# Operable Unit Carbon Tetrachloride Plume Upper 180-Foot Aquifer Remedial Design Addendum Former Fort Ord, California

Report Date: **September 2023**  
Report Version: **Draft Final**

CARBON TETRACHLORIDE PLUME  
LOWER 180-FOOT/400-FOOT AQUIFERS  
THIRD QUARTER 2022  
Operable Unit Carbon Tetrachloride Plume  
Upper 180-Footer Aquifer Remedial Design Addendum  
Former Fort Ord, California

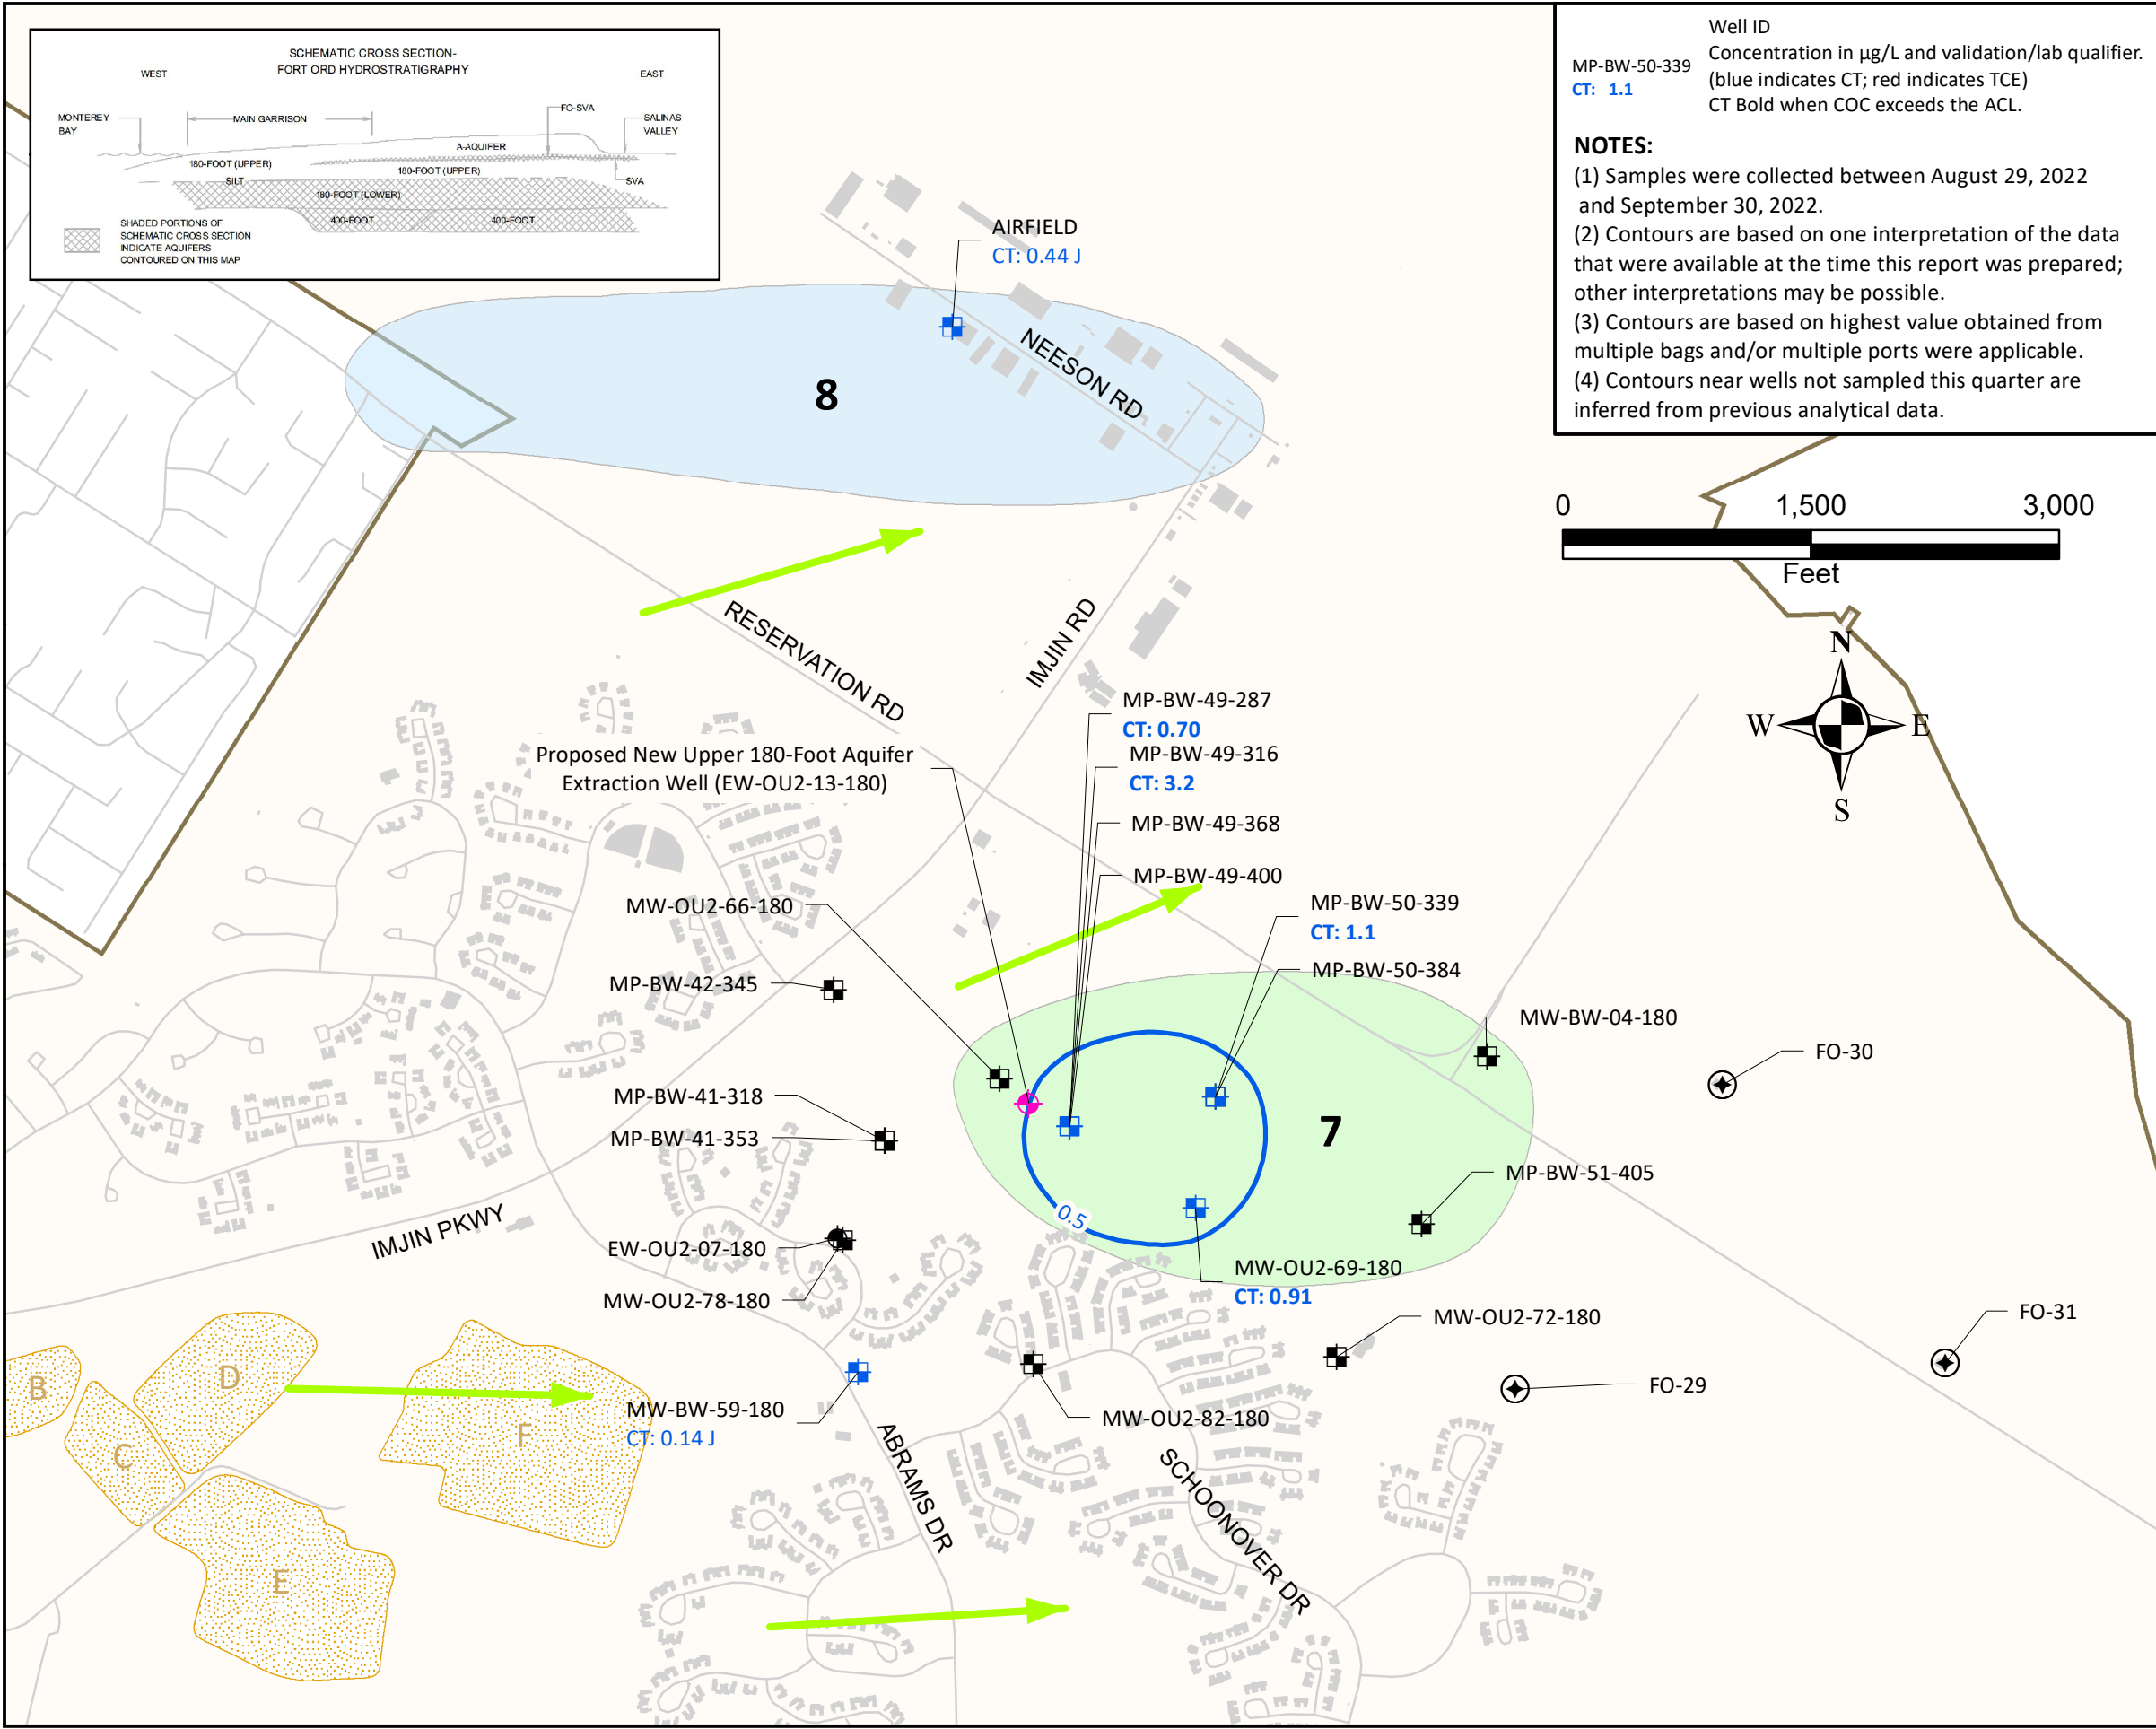
**SPECIFIC COMMENT 5: Figure 3, Carbon Tetrachloride Plume, Lower 180-Foot/400-Foot Aquifers – Third Quarter 2022:** The symbol for well BW-50-339 should be blue because CT was detected at 1.1 micrograms per liter ( $\mu\text{g/L}$ ), rather than a black symbol that indicates there are no CT detections. Please revise this figure accordingly.

**RESPONSE TO SPECIFIC COMMENT 5:** *Figure 3 was revised per the comment.*

**COMMENT 3:** Figures 2,3, and 4 need better background definition. It is difficult to visibly establish locations of the various plumes and wells without labeling roadways and nearby housing areas.

**RESPONSE TO COMMENT 3:** Road names were added to Figures 2, 3, and 4 per the comment.
